SITE AUDIT REPORT

ROAD INFRASTRUCTURE

AT 1C SYDNEY STEEL

ROAD, MARRICKVILLE

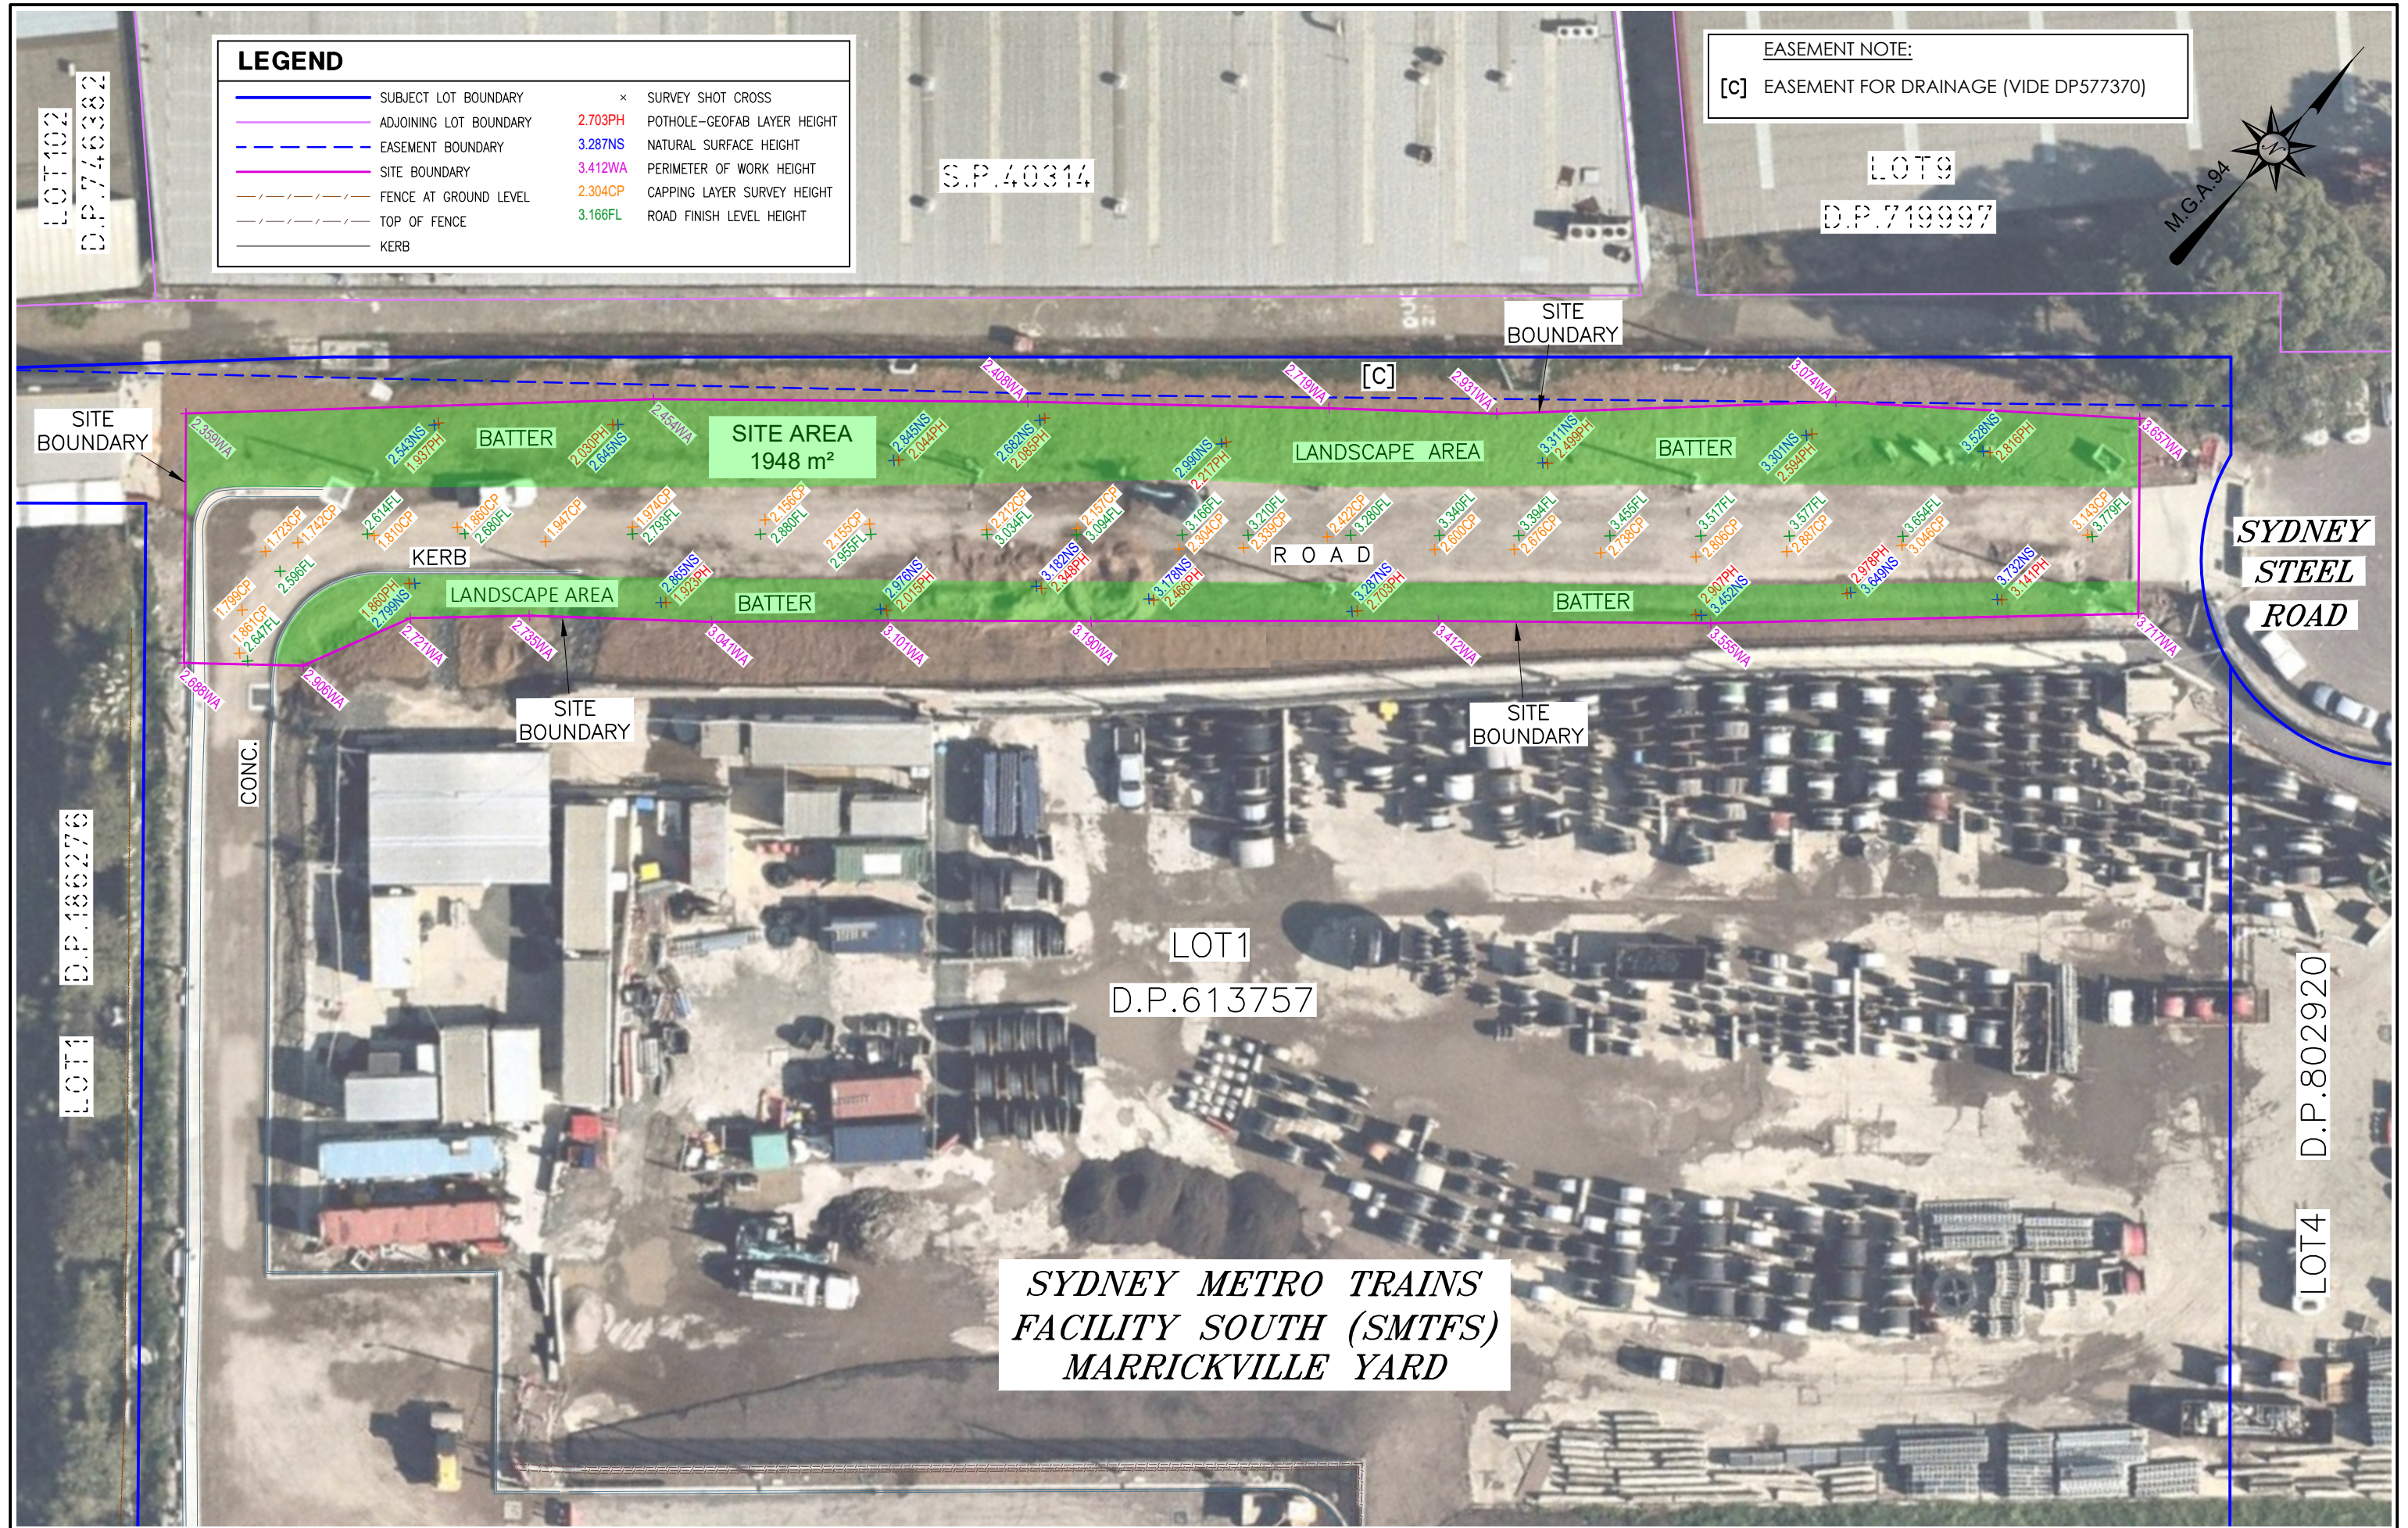
Based on the information presented in the survey plan, Alliance noted that the thickness of capping placed above the marker layer in the road portion of the site ranged from approximately 0.61 to 0.94 m while the thickness of capping placed above the marker layer in the landscaped areas of the site ranged from approximately 0.55 to 0.96 m.

Alliance reported that the capping thickness at two locations within the road portion of the site near the western boundary marginally did not meet the planned thickness (0.683 m) specified in the RAP. Alliance considered that *".....although the planned thickness of the capping layer was not achieved, the actual thickness and material type (engineered subgrade and hardstand pavement) is sufficiently adequate to break the exposure pathway between identified sources and receptors on site, based on the proposed land use scenario, subject to ongoing management of that capping layer."*
